RE: Notice of Screening for Blue Star Gold Corp.'s "Hood River Gold Project" Proposal (19EA019)

Appendix

GN-01: Terrestrial Wildlife Effects	
Department	Environment
Organization	Government of Nunavut
Subject/Topic	Terrestrial Wildlife interaction with the Project
References	<ul style="list-style-type: none"> • NIRB Application for Screening #125461 – Hood River Gold Project – Blue Star Gold Corp. • NIRB Public Notice of Screening and Comment Request for Blue Star Gold Corp.'s "Hood River Gold Project" Project Proposal • Effects Assessment (2019) – Hood River Gold Project – Blue Star Gold Corp. • Environment and Heritage Resources Protection Plan (2019) – Hood River Gold Project – Blue Star Gold Corp. • Project Description (2019) – Hood River Gold Project – Blue Star Gold Corp. • Wildlife Protection Plan (2019) – Hood River Gold Project – Blue Star Gold Corp. • The Bathurst Caribou Range Plan (2018) – Government of the Northwest Territories. • Environmental Dynamics Inc. (EDI). (2008). Yukon Environment - Flying in Caribou Country – How to minimize disturbance from aircraft • Poole, K.G. and Gunn, A. (2015). Mobile Caribou Conservation Measures for the Kivalliq Region, Nunavut. Fi

Figure 1: Hood River Project in Relation to Bathurst Caribou Seasonal Ranges

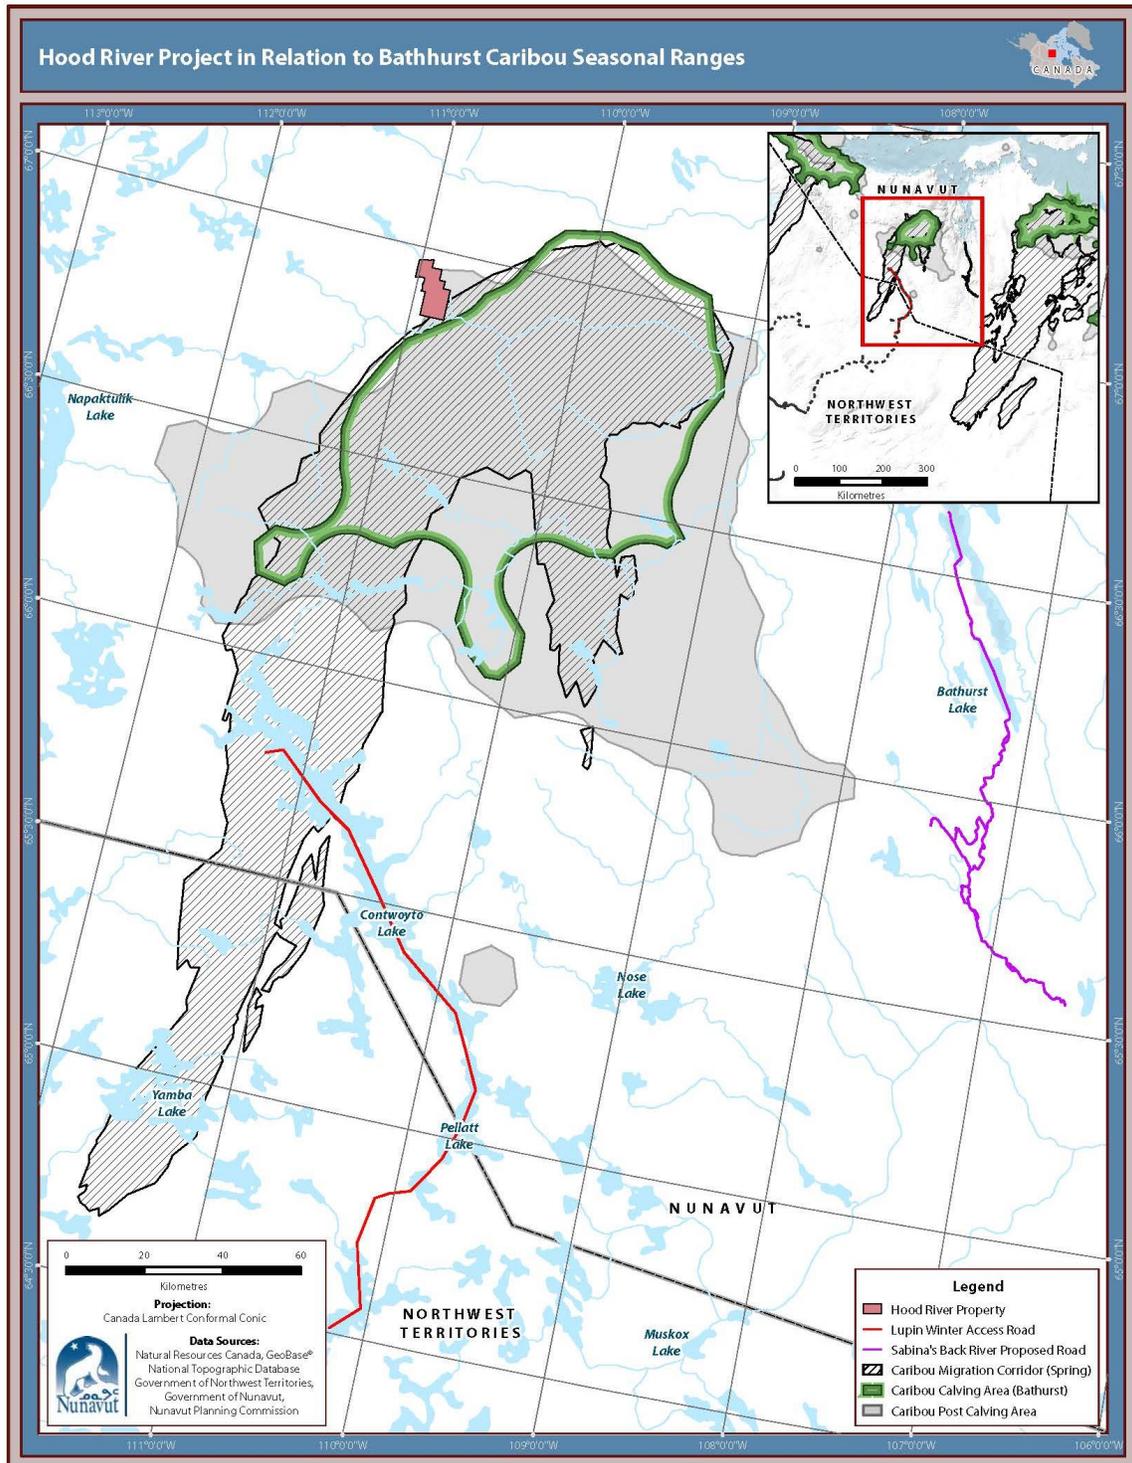
CONCERNS	
<p>The Project proposal contains insufficient information, which impedes the GN's accurate assessment and review of the Projects potential environmental effects. The Project may potentially cause significant adverse impacts on wildlife habitat if the appropriate mitigation is not identified and implemented.</p> <p>1. <u>Cumulative Impacts on Caribou Ranges</u>: The proposed Project area is located within the annual ranges of Dolphin-Union and Bathurst caribou herds and the Project activities may affect caribou migration. The Project area is also adjacent to the Bathurst caribou herd calving area and within the Bathurst caribou herd post-calving area (see figure 1). The potential impacts of the Project activities may affect these areas and cause caribou disturbance during calving and post-calving.</p> <p>The proposed Project, together with other existing and approved Projects in the area (e.g. Tibbit road, Sabina road, Lupin Winter Access road), may cause cumulative effects</p>

on Dolphin-Union and Bathurst caribou herd's habitat quality and abundance. The cumulative effects may also affect other wildlife and vegetation. The proposed exploration activities are scheduled for May – October, potentially beginning as early as March. The Project's schedule overlaps with the Bathurst caribou herd calving and post-calving, which occurs throughout June. The Project proposal does not reflect potential impacts on Bathurst caribou herd calving and post-calving areas and does not provide an assessment of the cumulative effects on caribou herds in the area. In particular the Project application indicates no cumulative effects without providing any substantiation.

The Proponent shall not construct a camp within calving and post-calving areas.

1. A complete Project description with necessary details related to the proposed geophysics surveys;
2. The Project’s Zone of influence;
3. An assessment of potential cumulative effects;
4. Revision of the Wildlife Protection Plan that includes the detailed description of proposed mitigation measures and a monitoring program to ensure proposed mitigation is effective.
